MINISTRY OF INFRASTRUCTURE, TRANSPORTATION AND NETWORKS  
GENERAL SECRETARIAT FOR PUBLIC WORKS

SYKIA DAM

PANEL OF EXPERTS  
REPORT

SEPTEMBER 2010

**Fig. 6-7 - Cross section of the achellos cofferdam and upstream dam shell.**

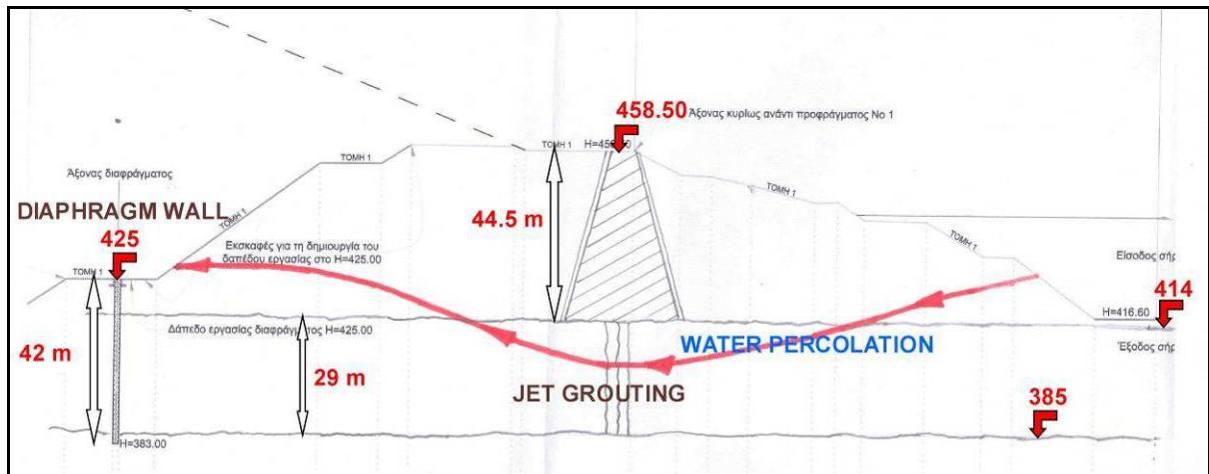
It is believed that water seeping through the alluvia deposits under the MUC, is forced by the watertight diaphragm wall to emerge over its crest, as shown in Fig. 6-7. It is obvious that the higher the water level in the lake upstream of the cofferdam, the higher the water flow emerging over the diaphragm wall.

During a flood in 2009, (after construction of the diaphragm wall), the water level upstream of the cofferdam reached elevation +434.00 m. High water flow was observed at the downstream face of the cofferdam, above the diaphragm wall. The flow was assessed (not recorded) at  $\sim 2 \text{ m}^3/\text{sec}$ .

**Fig. 6-8 - Probability of Reaching the Bench Mark 425.00 for Several Scenarios**

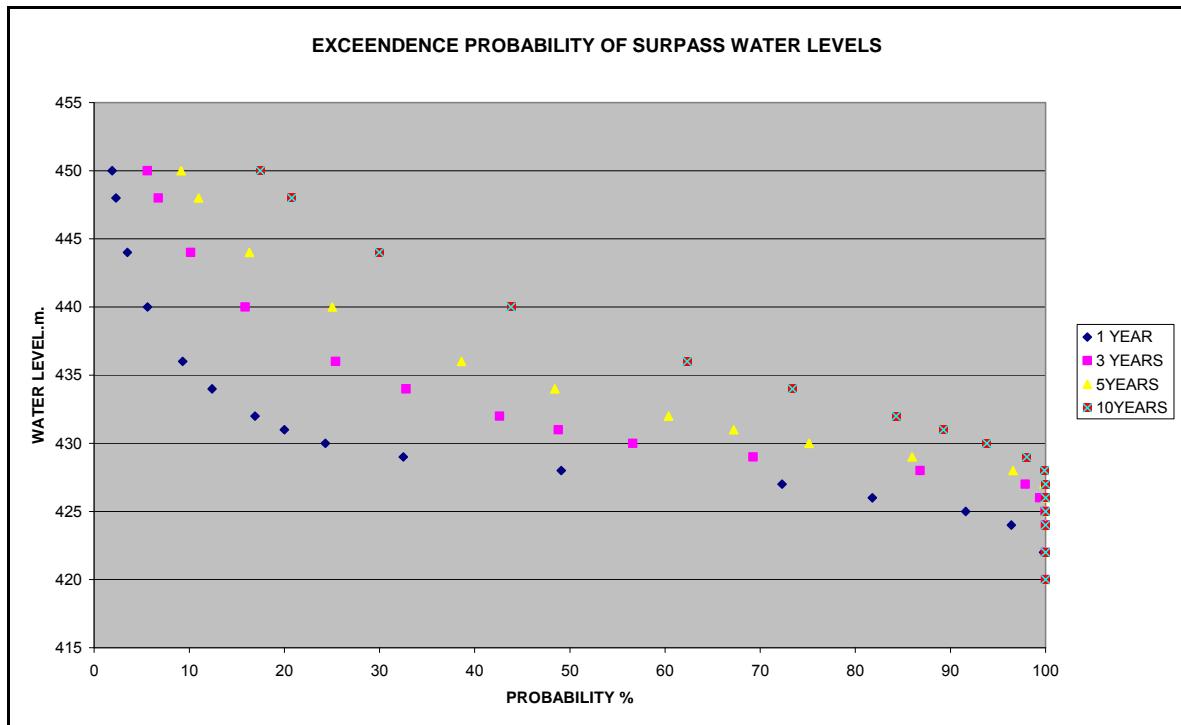
The hydrological analyses show that the probability of reaching the bench mark +425.00 is very high, being evaluated currently at 91,6% while in the +5 and +10 years scenarios it is practically 100%, as shown in Table 6-7 and Fig. 6-8.

Fig. 9-1 – Solution with U/S facing associated with a toe diaphragm

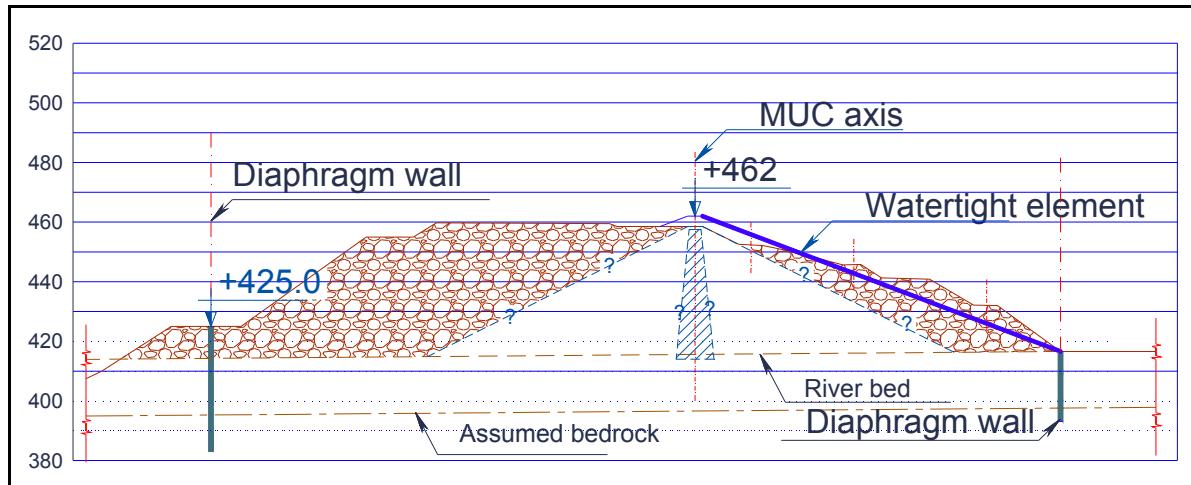
The river alluvia should also be made watertight by construction of a vertical diaphragm constructed in panels by hydro fraise and plastic concrete, or piles or even grouting by tube a manchette method or otherwise. The technology for diaphragm construction, taking into account the characteristics of the alluvium, is well established today, so this method is easily applicable.

Fig. 9-2 – Cofferdam over existing diaphragm wall

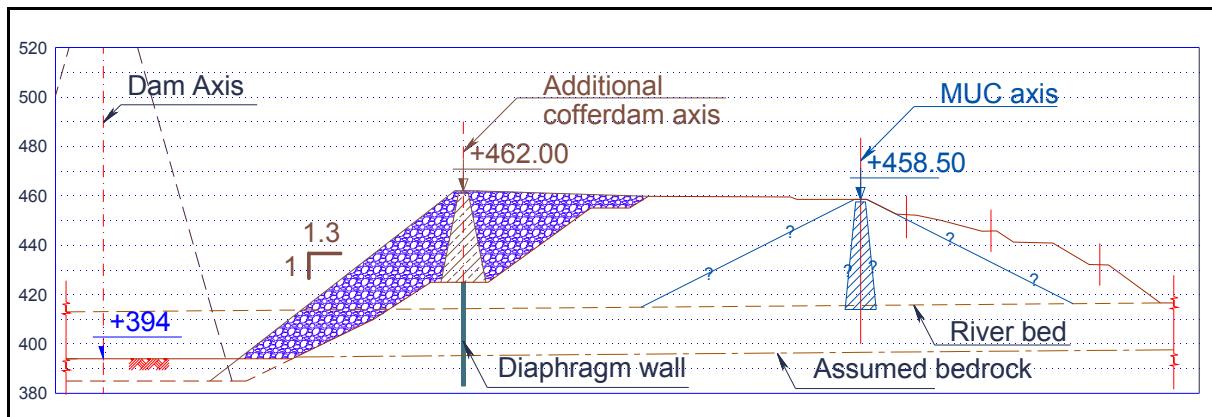
This solution exploits the existing diaphragm wall (which has proved to be a well functioning watertight element). by building an impervious core over it and extend the core up to the required elevation. In this case the height of the core would be 37 m above the diaphragm head.

The downstream shell should be made with the available stockpiled materials. It is estimated that the friction angle of the stockpiled materials could be as high as  $37^\circ$  to  $39^\circ$  with no cohesion. The actual values should be determined by relevant laboratory testing. A filter and drain system should be designed and incorporated.
